TOWN OF SULLIVAN'S ISLAND DESIGN REVIEW BOARD

REGULAR MEETING MINUTES Wednesday, February 15, 2023

808 Star of the West Street: Daphne Wertz, representative of Mc3 Designs, LLC, requested preliminary approval to construct a one-story addition on the side of the existing home with a request for side setback relief and principal building side façade relief. (PIN# 523-06-00-078)

RIGHT ELEVATION - PROPOSED
1/8" = 1'-0"

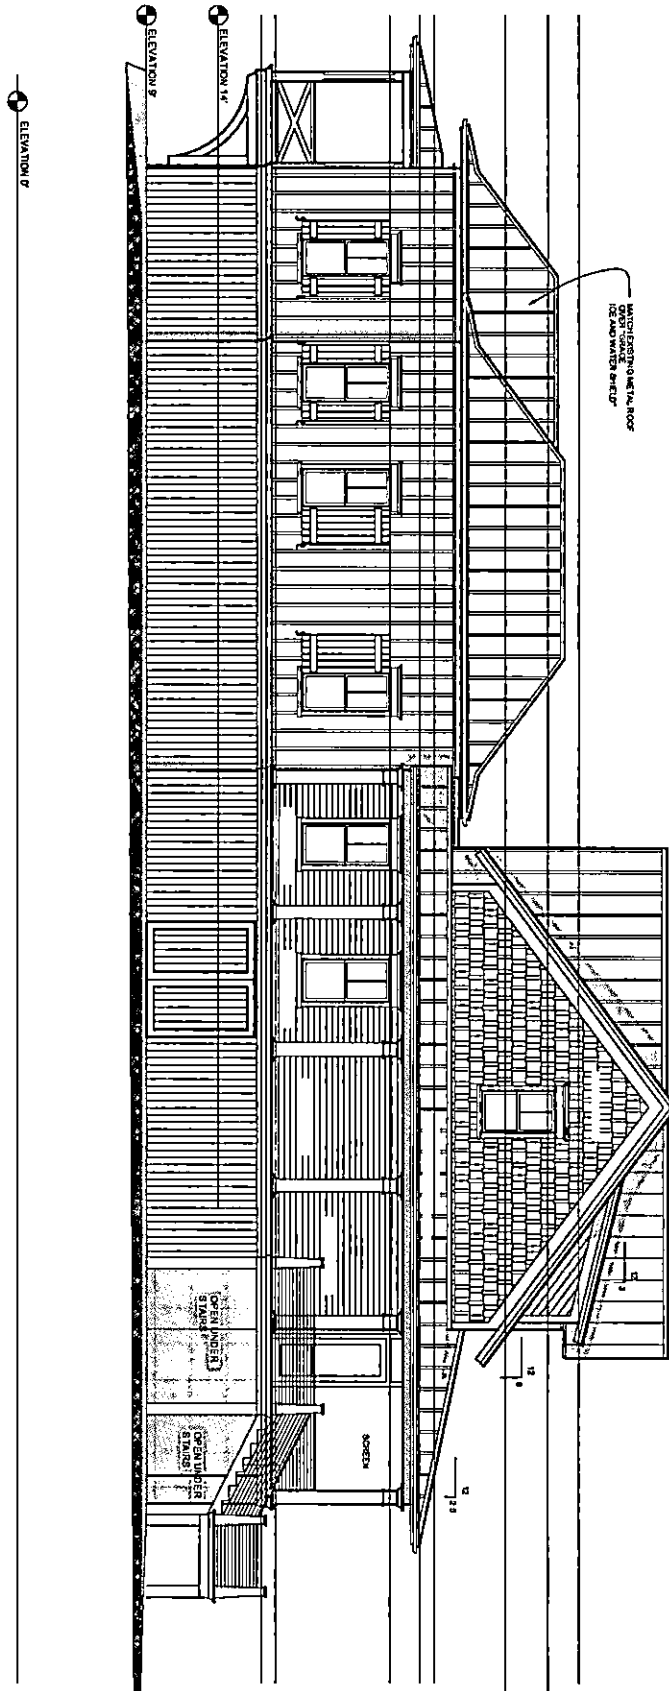
Mr. Clarke voiced his concern regarding the long wall and roof on the side elevation of the addition. Mr. Clarke suggested removing the porch and creating more of a balcony on the master suite addition.

Mr. Clarke made a motion to grant preliminary approval for the application presented provided the applicant review the porch and to address the long wall and roof of the side elevation. Mr. Askins seconded this motion. Motion passed 3 to 1. Ms. Wilson opposed.
